SUGGESTED CHANGES TO YORK STATION FRONT DEVELOPMENT

13 Sep 2019

A: The CYC/Arup Proposal

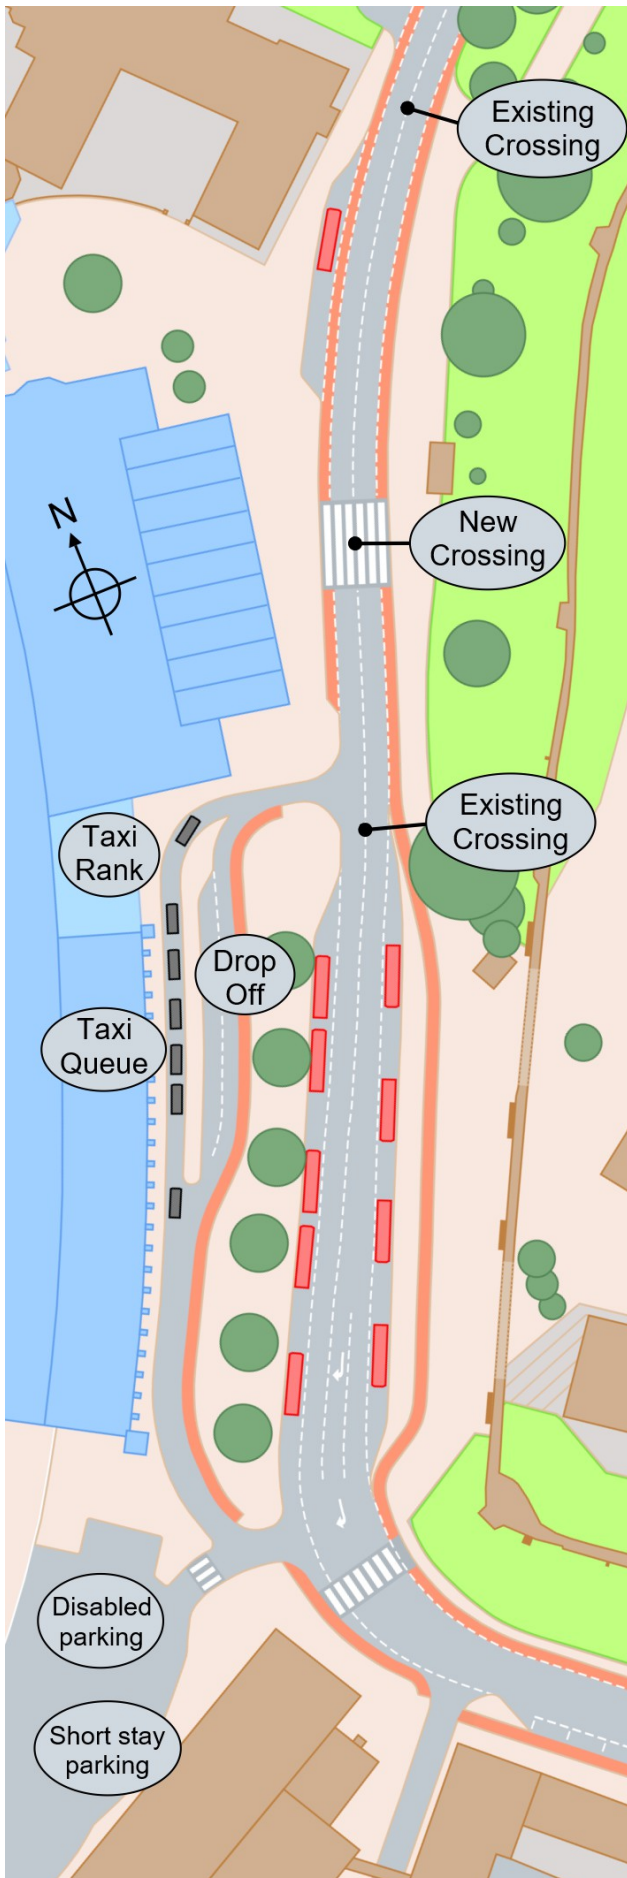
Closer integration of the bus interchange and the railway station is prevented by the location of the taxi queue. There is no practical requirement for waiting taxis to be close to the train shed wall, but bus stops in this location could very usefully be integrated with a concourse inside the train shed. We do not however propose this be done at this stage. The Station Front development would be a first step towards this ultimate goal.

The drop-off also lies between the northbound bus stops and the train shed, also limiting scope for integration, so from this point of view would be better located elsewhere.

The new central crossing outside the portico appears to have been conceived with the sole aim of making it more pleasant for visitors to go from the station portico to the city centre. But the station has numerous entrances, and therefore many other pedestrian movements to consider. The location of the crossing makes some of these longer without any significant reduction in others.

B: East Side Modifications

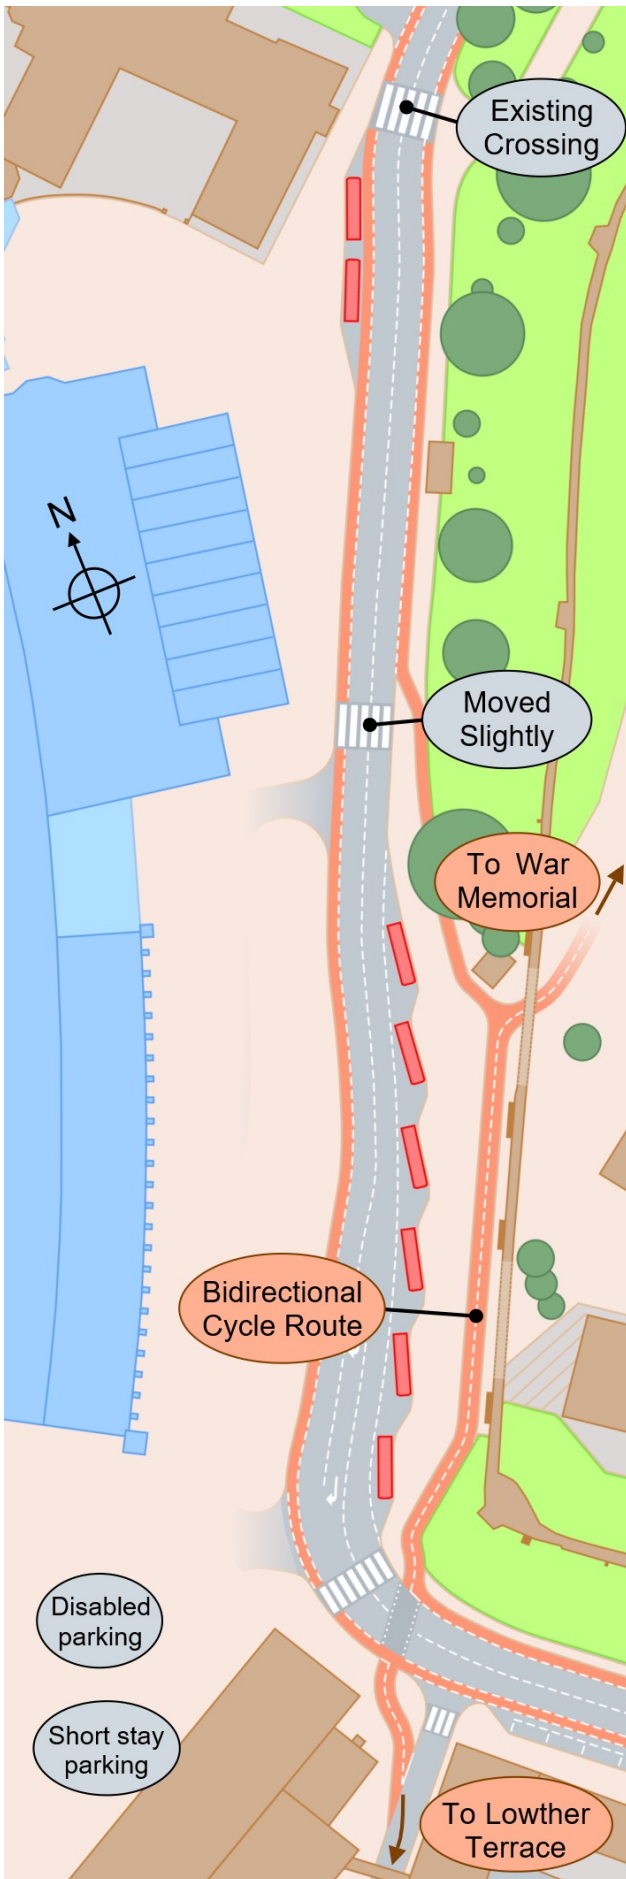
The original locations of the crossings outside the Principal Hotel and Parcel Square are on the whole better from a walking distance point of view.

There is no longer a need for a direct crossing to the bus stops opposite because they are to be relocated southwards.

There is no longer a need for a new uncongested route from the portico to the city centre because the portico and Tea Room Square are to be pedestrianised.

So on the whole the new crossing has no practical advantage, numerous disadvantages, and limits the use that the space outside the portico can be put to.

Crossings at the existing locations are on the whole a better proposition.

The cycle path in the CYC/Arup proposal passes unnecessarily close to the bus stops, creating needless conflict between cycles and pedestrians.

A better alternative would be to route it nearer to the bar walls as shown.

This proposal goes further in suggesting a major and remarkably direct bidirectional cycle route between the War Memorial to the north and Lowther terrace (off Holgate Road) to the south, using largely traffic-free roads that already exist.

Compared to the CYC/Arup proposal, the cycle track on the station side is directly alongside the road, which avoids the fragmentation of the route in the CYC/Arup proposal. As the following pages will show, the potential conflict between cycles and buses is much reduced.

D: A Future Possibility

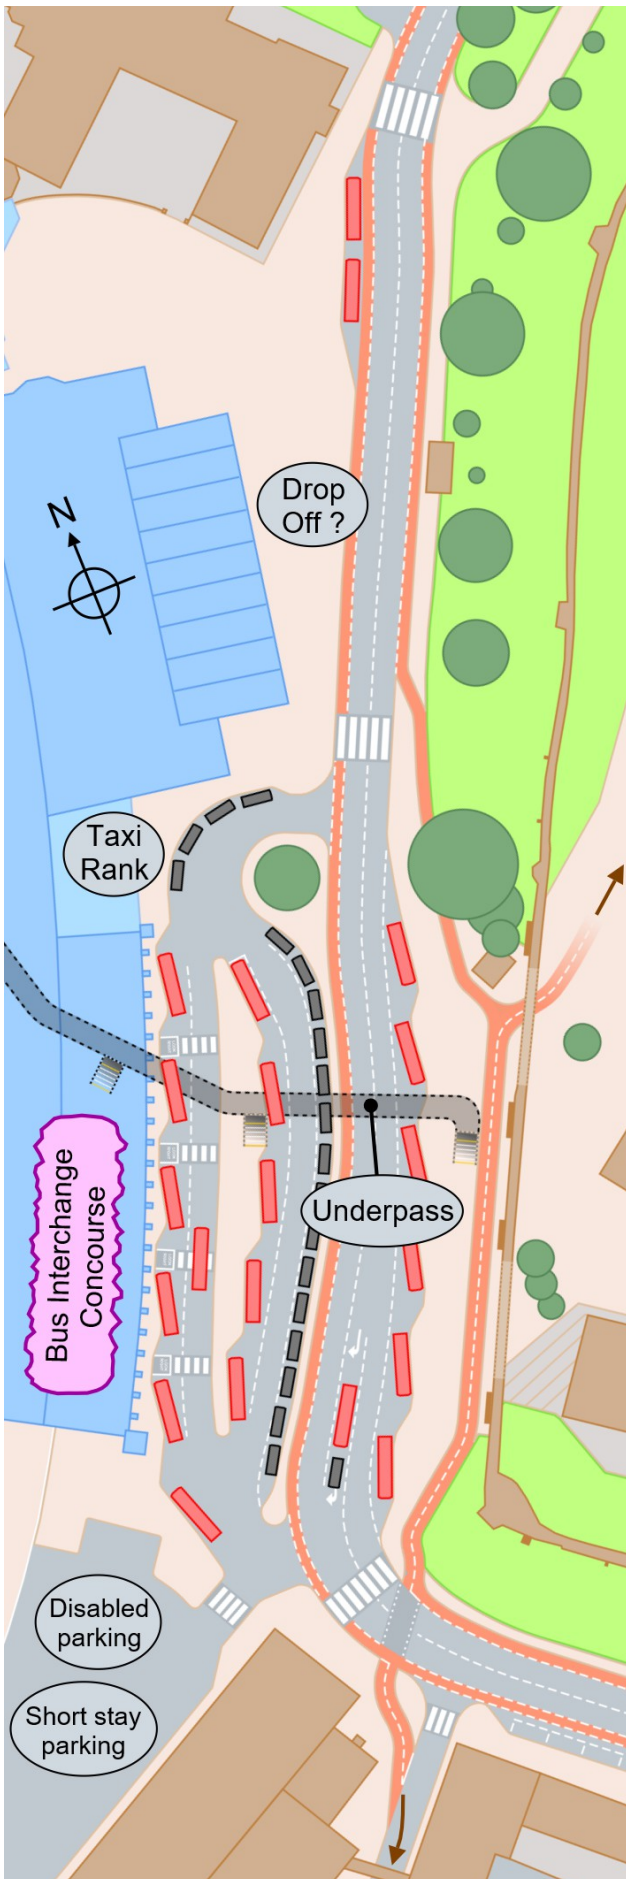
By sacrificing the most southerly of the bus stops on the west side, another bus lane and row of stops can be accommodated in the large paved area left by the Station Front development.

With two lanes the limited space available makes it difficult to provide a wide enough and uncongested paved area between the buses and the train shed wall, but the wall contains a succession of arches. By removing the infill from some of these, a bus station concourse can be put inside the train shed.

Thus the interchange's pedestrian area is much enhanced. The concourse is under cover without the need to construct a bus interchange building, and integration with the railway station is maximised.
